LANDSCAPE - SSDA

QANTAS GROUP FLIGHT TRAINING CENTRE, 297 KING STREET, MASCOT, 2020

20180199: LANDSCAPE ARCHITECTURAL DRAWING LIST

SCHEDULE OF UPDATES - LANDSCAPE ARCHITECTURE

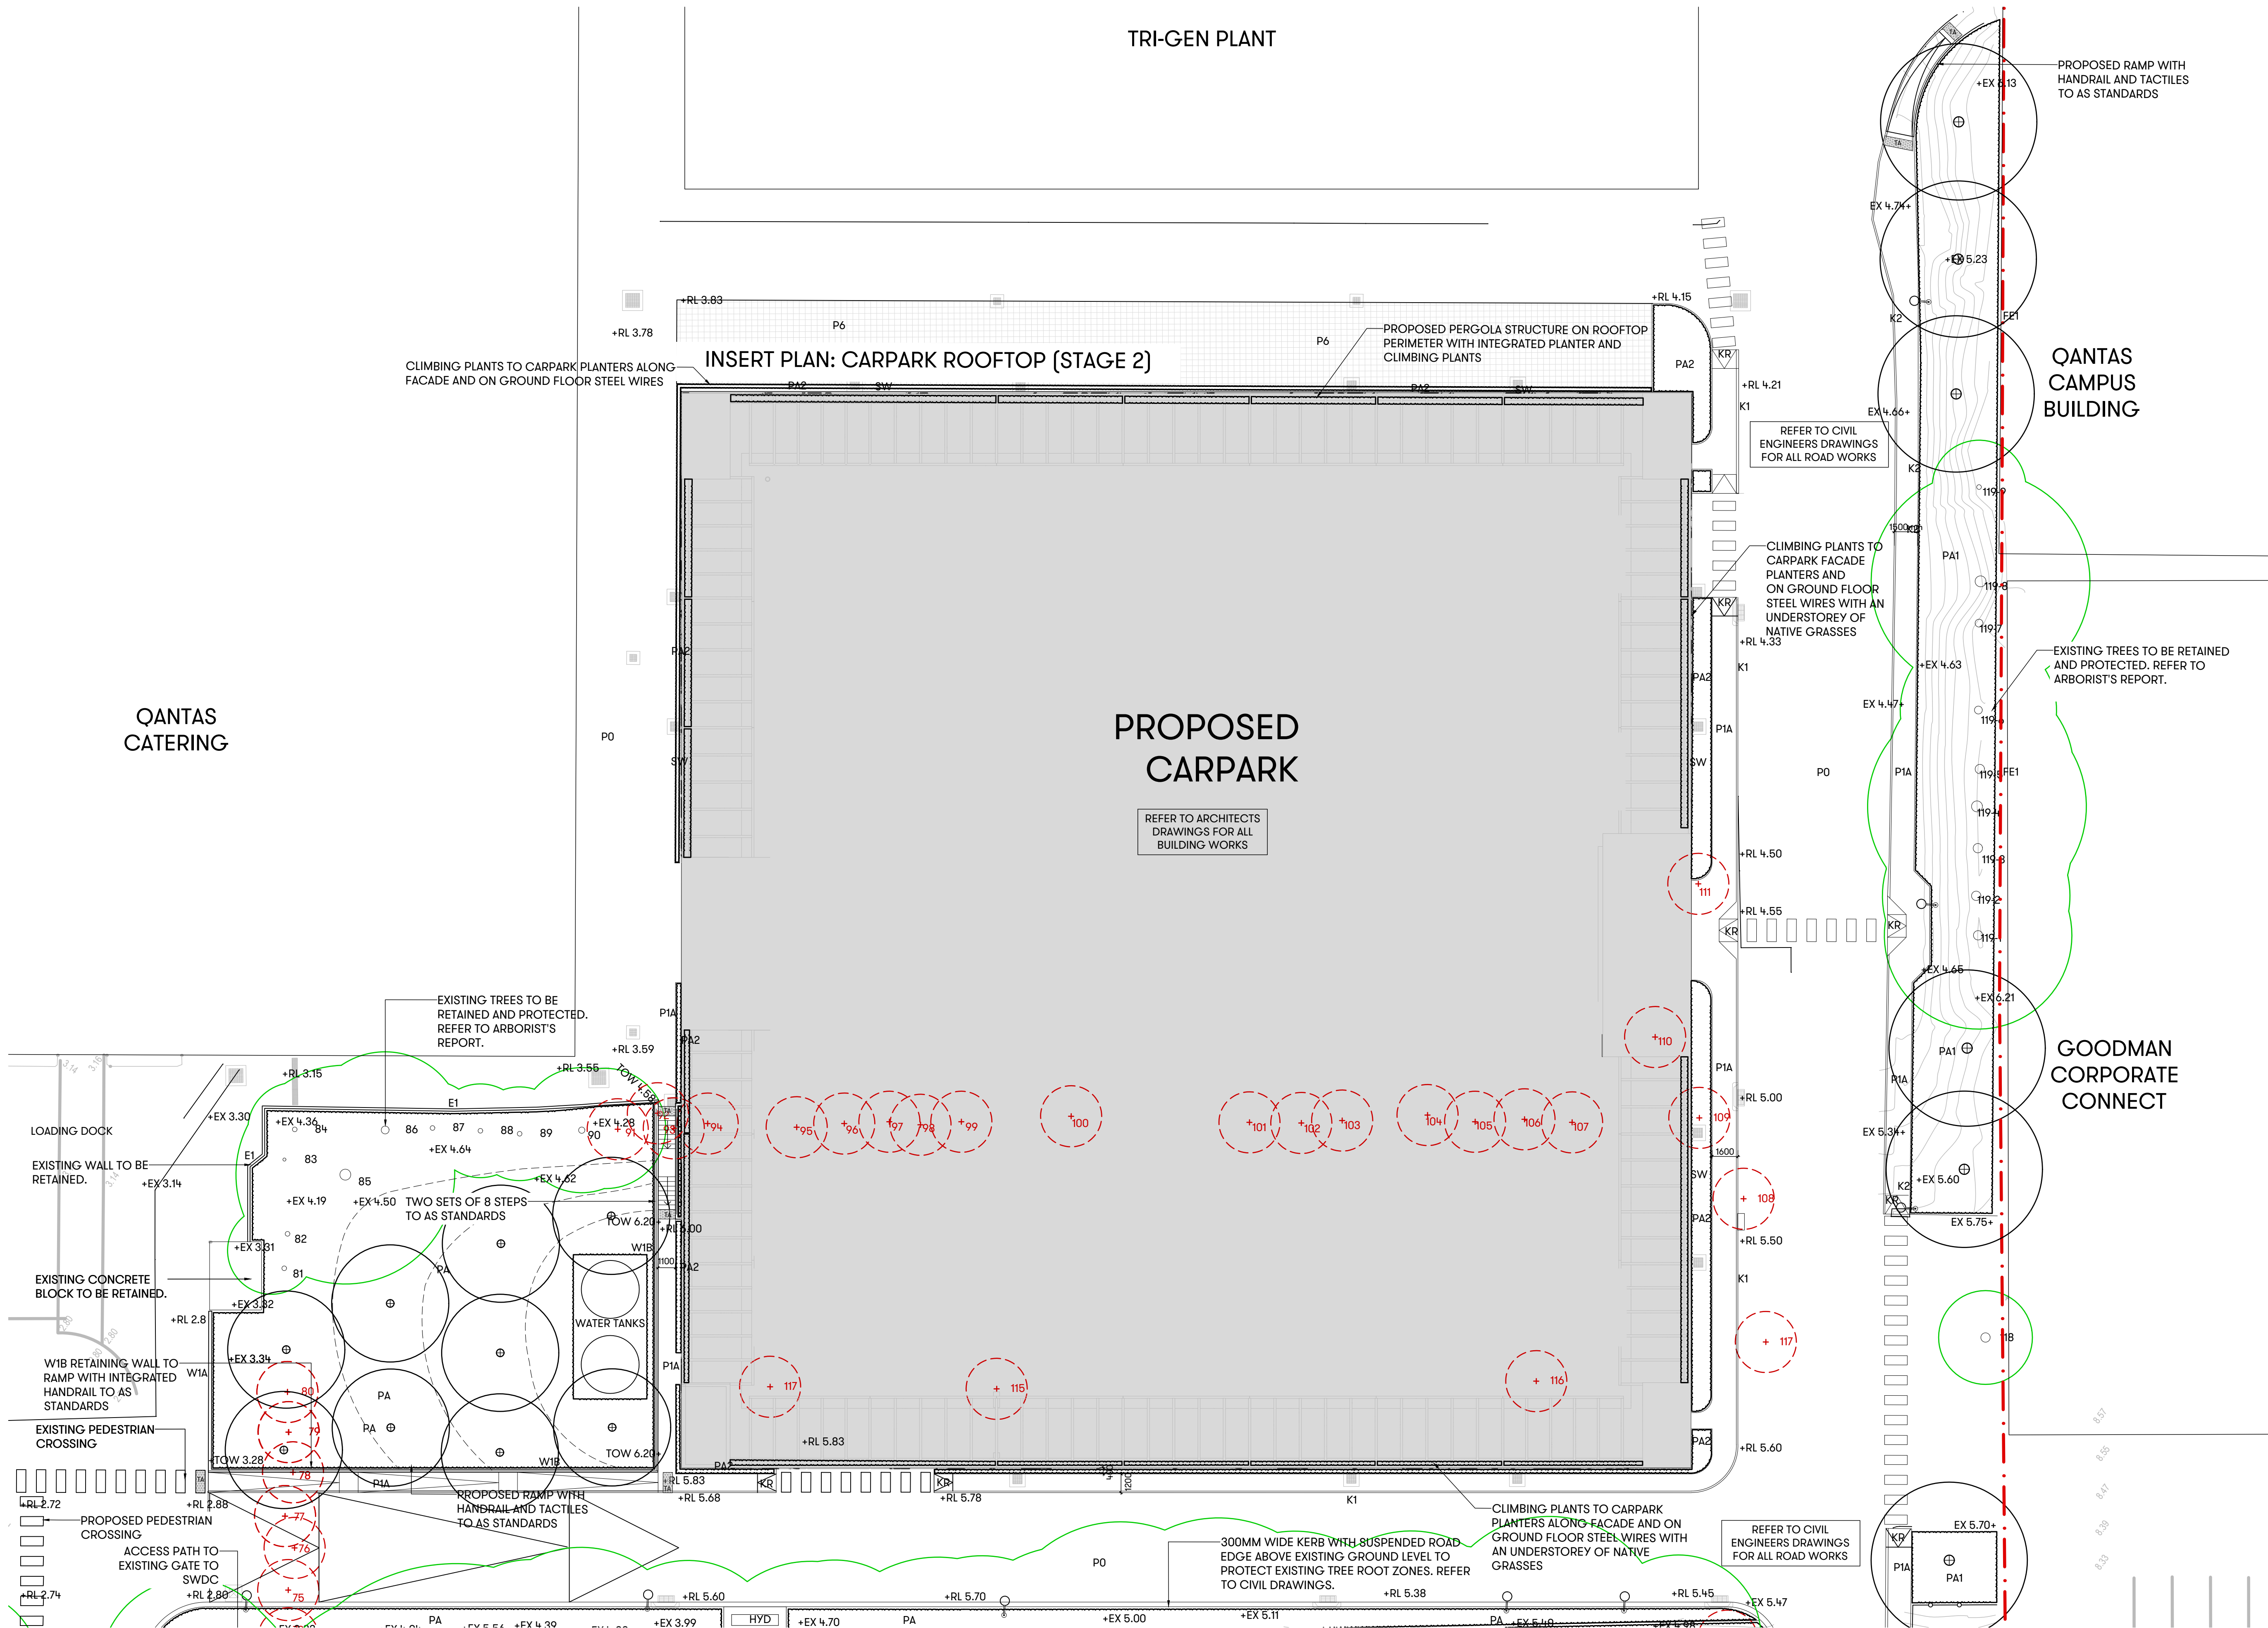
LANDSCAPE ARCHITECTURAL DRAWINGS	MAIN UPDATES
LD-DA000[2] COVER SHEET	+ Drawing Revisions
LD-DA100[2] GENERAL ARRANGEMENT LAYOUT	+ As below
LD-DA101[2] GENERAL ARRANGEMENT 1	<ul style="list-style-type: none"> + Additional climbing plants to ground floor of carpark facades north & west + Additional facade planters to north, east & west elevations (shown by note on drawings, refer to Architect's drawings) + Tree 73 to be removed, Tree 108 to be removed (added to drawing) + Additional proposed trees where possible + Porous paving to northern carpark + Design development & detail to materials and furniture
LD-DA102[2] GENERAL ARRANGEMENT 2	<ul style="list-style-type: none"> + Above as applies + Additional proposed trees & planting area where possible + Design development & detail to materials and furniture
LD-DA103[2] GENERAL ARRANGEMENT 3	<ul style="list-style-type: none"> + Additional proposed trees to northern car parking area + Porous paving to Fire Trainer and car parking areas + Rain gardens to planting areas adjacent to car park spaces + Additional planting area & proposed trees where possible + Design development & detail to materials and furniture

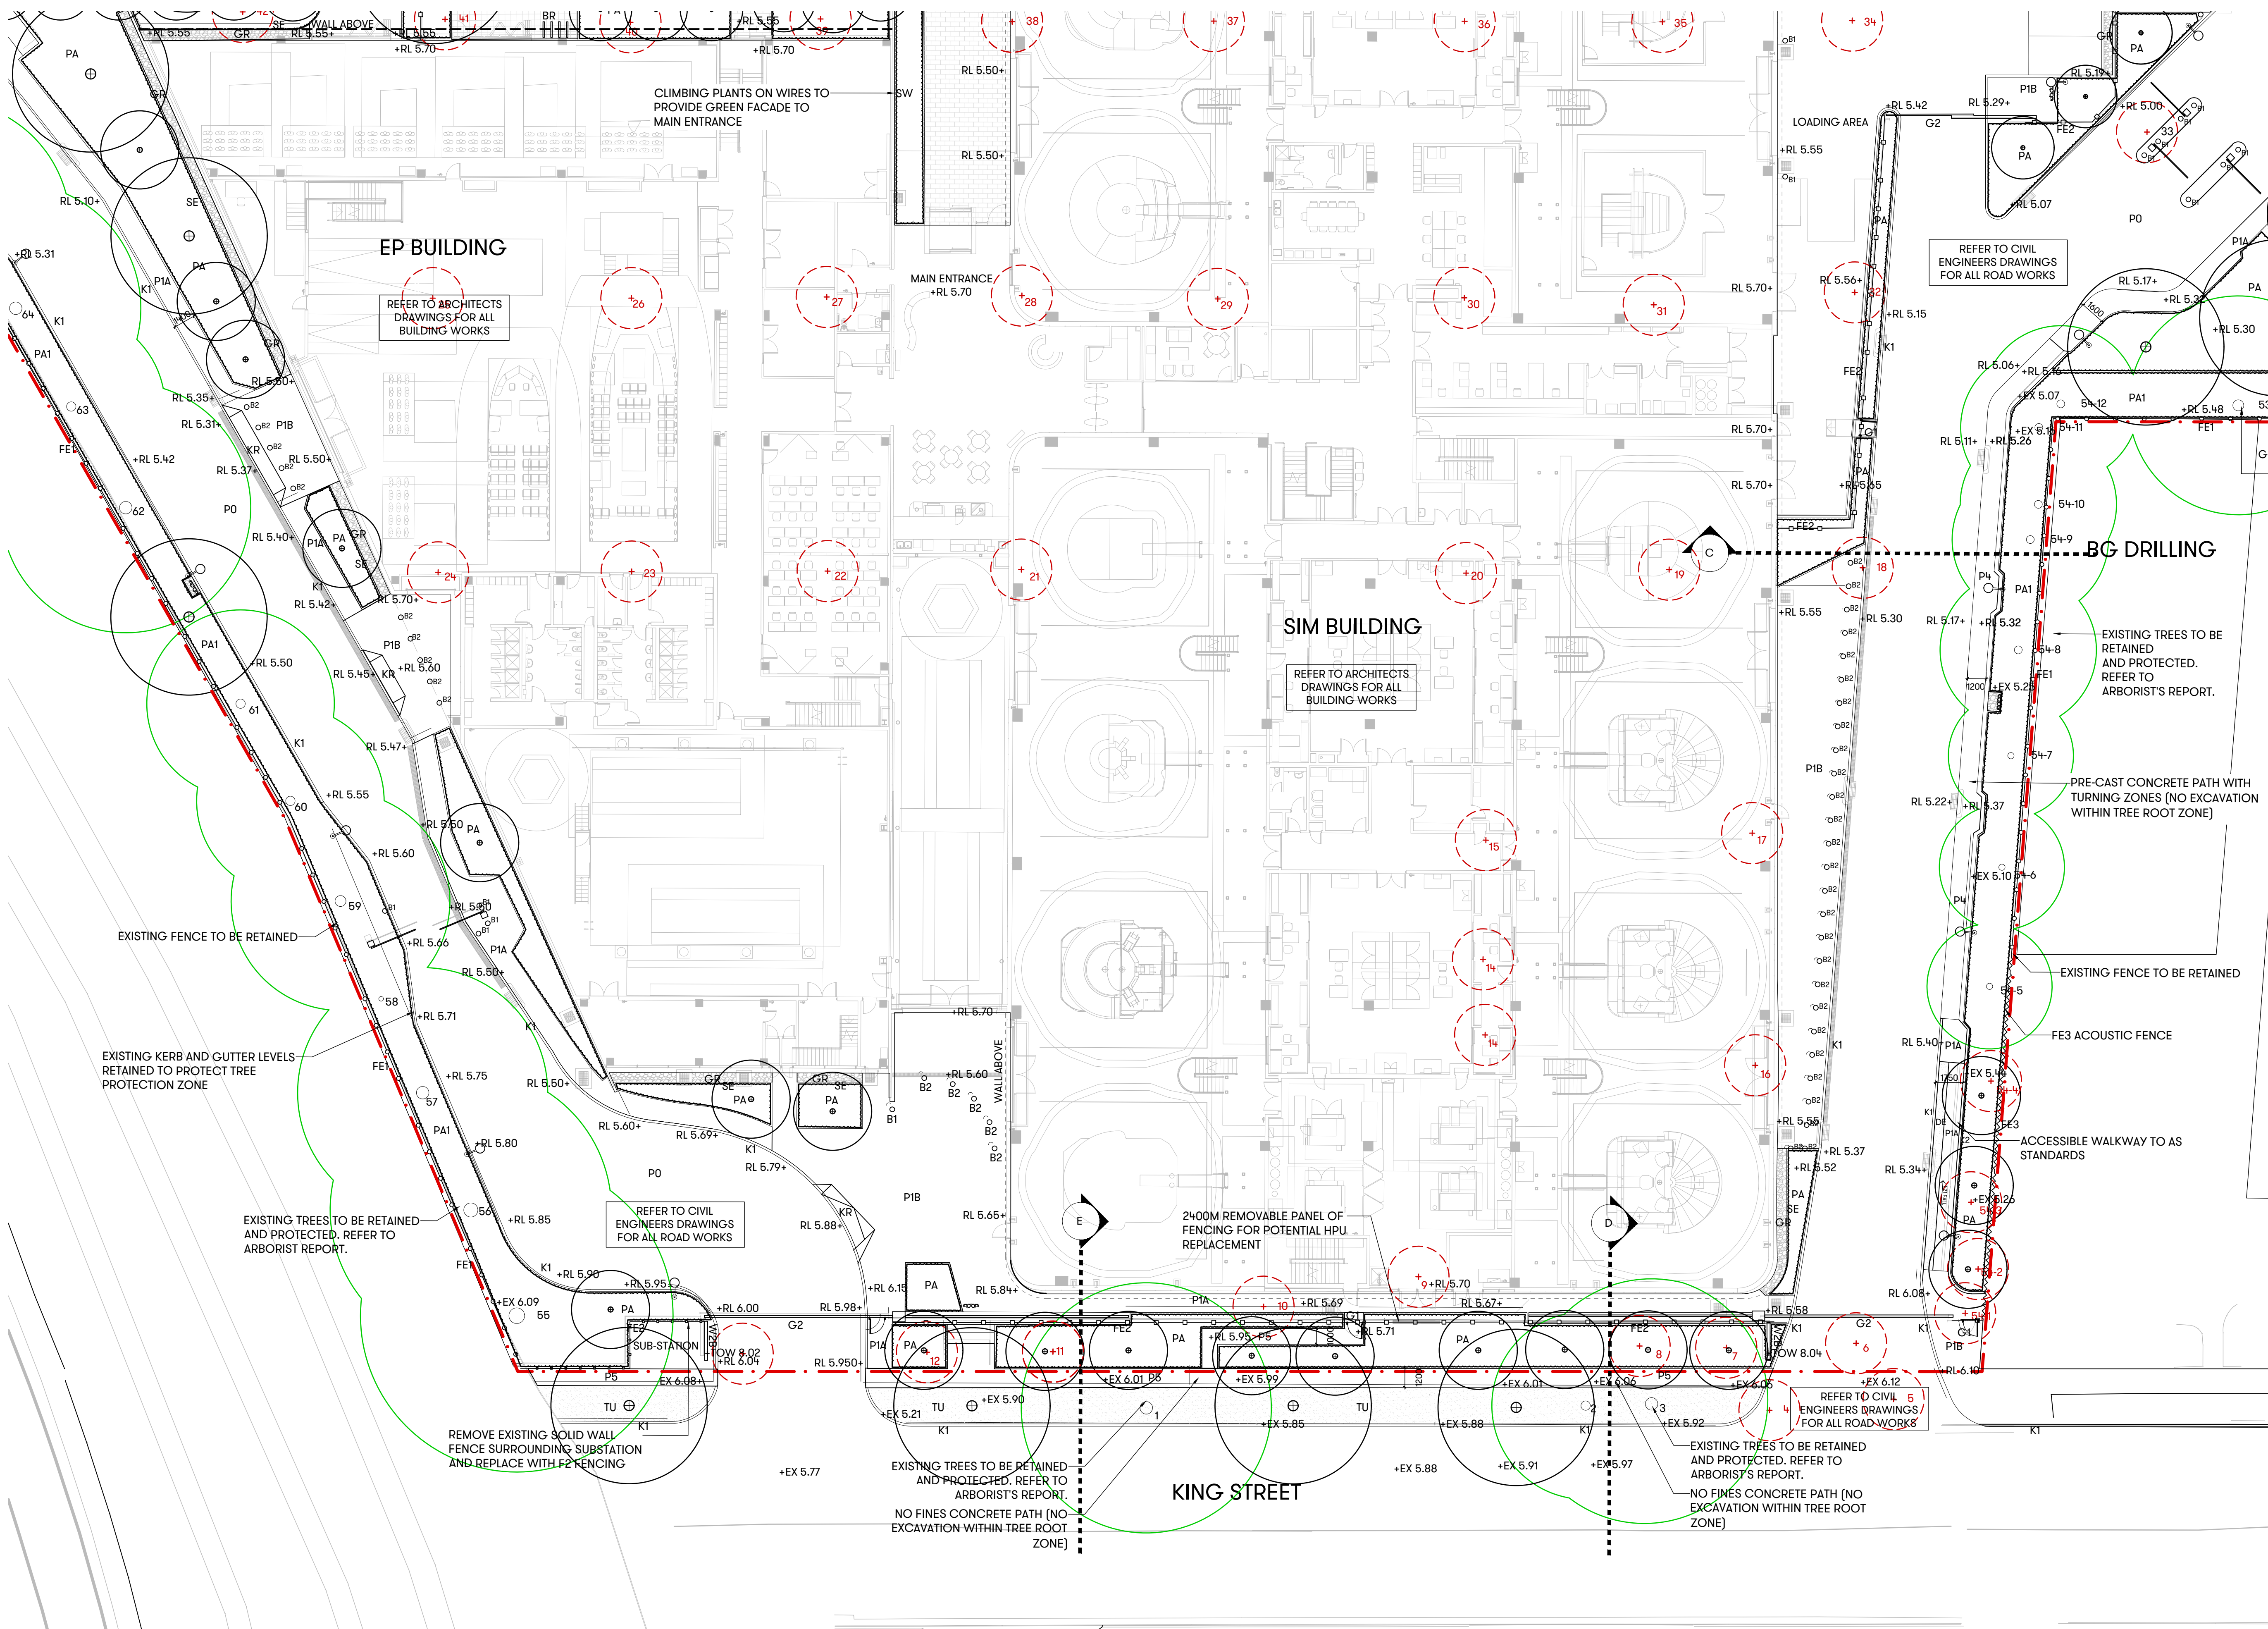
LD-DA104[2] GENERAL ARRANGEMENT 4	<ul style="list-style-type: none"> + Additional proposed Eucalyptus haemastoma trees to Public Domain nature strip + Tree 11 & 8 to be removed as per Arborist's Report + Additional planting area & proposed trees where possible + Design development & detail to materials and furniture
